SUBARU

SERVICE BULLETIN

NUMBER: 09-54-12

SUBJECT: High-Pitched “Chirp,” “Squeak” or “Cricket”
 Sound from the Engine

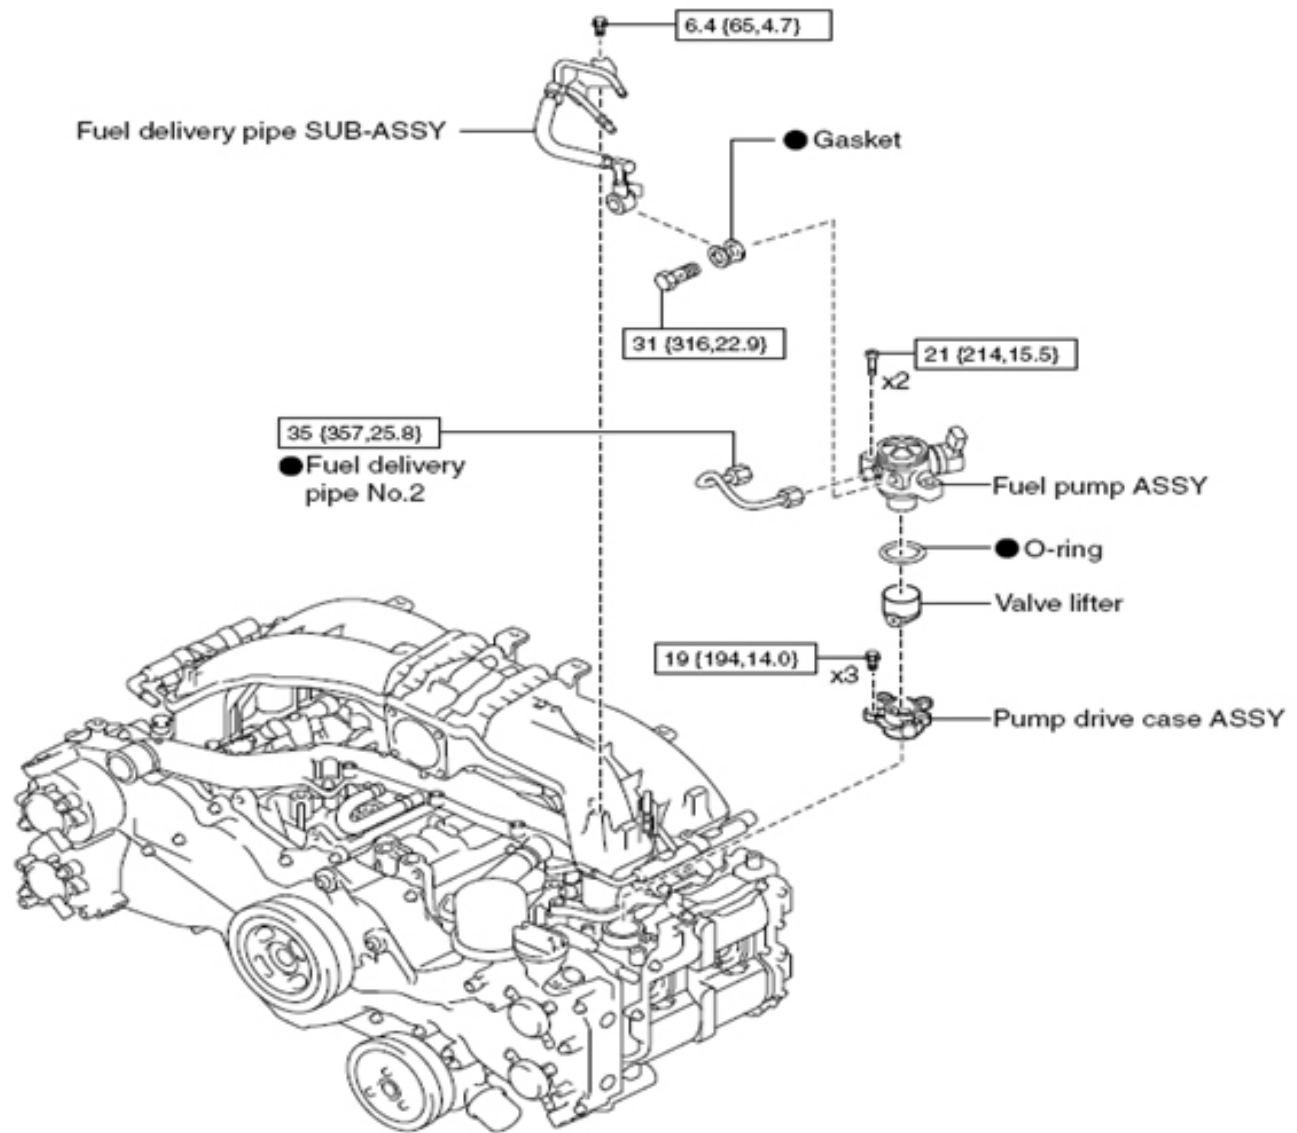
- Items indicated in the exploded view with a ● are “non-reusable” and **MUST** be replaced.
- The o-ring is included with the fuel pump assembly.
- Part numbers and quantity required to complete the procedure are listed below.

IMPORTANT: Always follow the tightening torque specifications as indicated in the applicable Service Manual (and the exploded view diagram on pg. 2) during re-assembly.

PART NUMBER	DESCRIPTION	QUANTITY
16625JB000	Fuel Pump Assembly	1
17540AA340	Pipe Assy. Fuel Delivery (No. 2)	1
17555AA040	Gasket, Fuel Pipe	1
14035AA610	Gasket, Intake Manifold	2
16175AA420	Gasket, Throttle Chamber	1
